## **Finding of Fact and Conclusion of Law**

The Michigan Department of Environmental Quality, Water Resources Division (WRD) has completed review of permit application # 2NN-5PE0-MT3W  
April 30, 2018

State land to east of project area

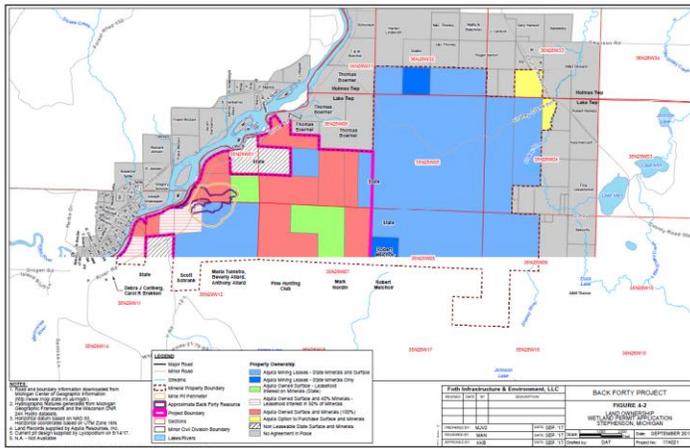
Wetlands Map Viewer does not show any wetland complexes on the State of Michigan land adjacent to the project area. Using Wetlands Map Viewer, I was able to measure 900 acres of upland adjacent to the project site and proposed development.

Aquila's application map shows that Aquila has both minerals and surface leases in the area of interest (SOM property).

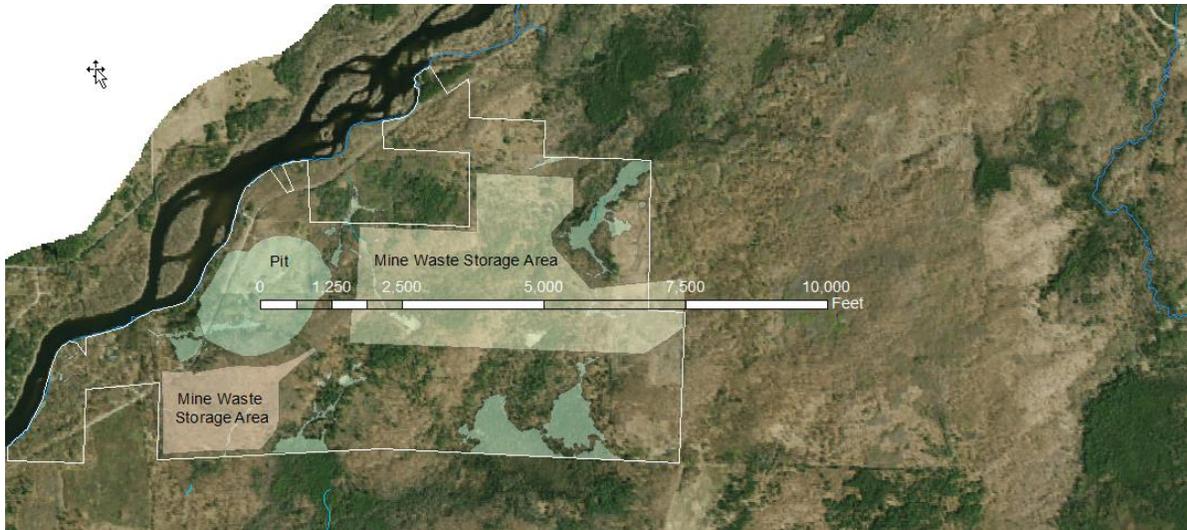
WRD Comment: This information is not consistent with information in the application. The wetlands application LEDPA states that this distance from the pit to the TWRMF is 3,900 feet. That measurement is made from the center of the pit to the center of the TWRMF. From the center of the pit to the east property line is 7,800 feet.

As measured on GIS:

- Approximate center of the mine pit to the proposed processing plant: ~3,800 feet
- Processing Plant to center of Mine Waste Storage Area (TWRMF): ~2,600 feet
- Processing plant to east property line (direct): ~4,800 feet
- Center of pit to east property line: ~7,800 feet
